Accepted for File
By: Christina Prete, PE
Stormwater Manager
Date: 12/03/2024 12:47:55 PM
El Paso County Department of Public Works

From: Nosker - DNR, Elizabeth <elizabeth.nosker@state.co.us>
Sent: Monday, August 26, 2024 2:58 PM
To: Schnelbach, Ryan
Cc: Kofford, Kevin; Monica Long - DNR; Jessica Wodiuk - DNR
Subject: Re: Non-Jurisdictional Structures - PT Eagleview LLC

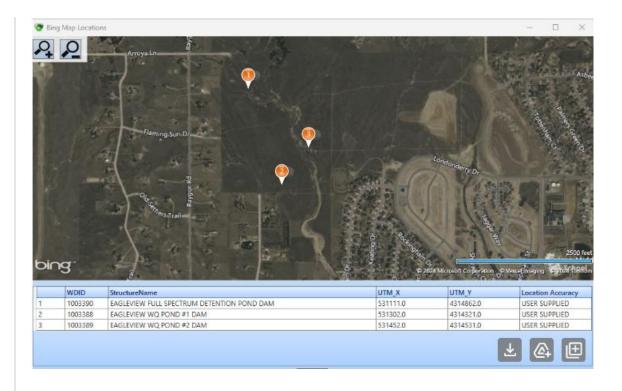
Have a great evening, Ryan Ryan Schnelbach | Development Services Kimley-Horn | 2 N Nevada Ave, Colorado Springs, CO 80903 Direct: 719.501.1723 Connect with us: Twitter | LinkedIn | Facebook | YouTube | Kimley-Horn.com From: Nosker - DNR, Elizabeth <elizabeth.nosker@state.co.us> Sent: Monday, August 12, 2024 5:37 PM To: Schnelbach, Ryan < Ryan. Schnelbach@kimley-horn.com> Cc: Kofford, Kevin < Kevin. Kofford@kimley-horn.com>; Monica Long - DNR < monica.long@state.co.us> Subject: Re: Non-Jurisdictional Structures - PT Eagleview LLC Hi Ryan, The UTM is still incorrect. The Datam should be UTM, NAD83. Our Lead GIS Specialist, Monica Long (cced here) tried to find the locations and came up with the following. Can you please take a look again?

As we discussed, I'll resubmit the forms with the updated coordinates provided below.

Regarding the freeboard comment, we will be able to get that resolved, per the plans we should be providing 1.0' of freeboard.

Monica – those locations look correct! Sorry for the confusion regarding the UTM data we provided.

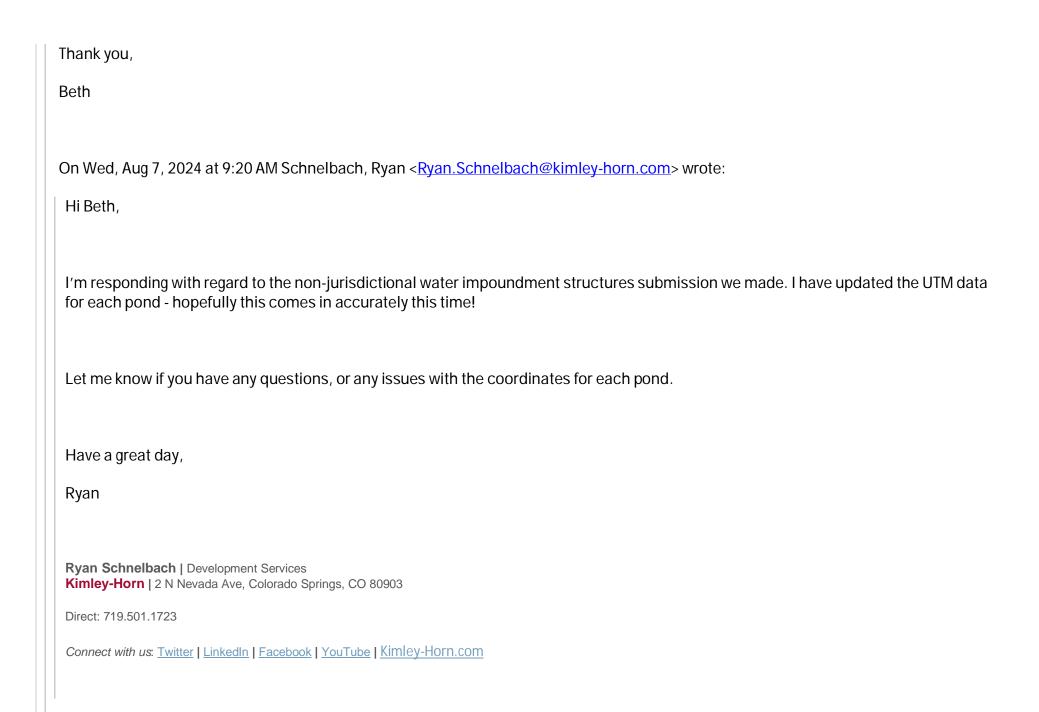
Attached are the updated forms. Let me know if you have any issues accessing these documents, or need anything else form us.
Thank you,
Ryan
Ryan Schnelbach Development Services Kimley-Horn 2 N Nevada Ave, Colorado Springs, CO 80903
Direct: 719.501.1723
Connect with us: Twitter LinkedIn Facebook YouTube Kimley-Horn.com
From: Nosker - DNR, Elizabeth < <u>elizabeth.nosker@state.co.us</u> > Sent: Wednesday, August 7, 2024 4:30 PM To: Schnelbach, Ryan < <u>Ryan.Schnelbach@kimley-horn.com</u> > Cc: Kofford, Kevin < <u>Kevin.Kofford@kimley-horn.com</u> > Subject: Re: Non-Jurisdictional Structures - PT Eagleview LLC
Hi Ryan,
I apologize for yet another email.
The width of the spillway bottom on the NOI and on the plans are different from each other for all three ponds. Can you please revise to the correct value?

No worries at all, my apologies on that! I misinterpreted how the dimensions should be provided.
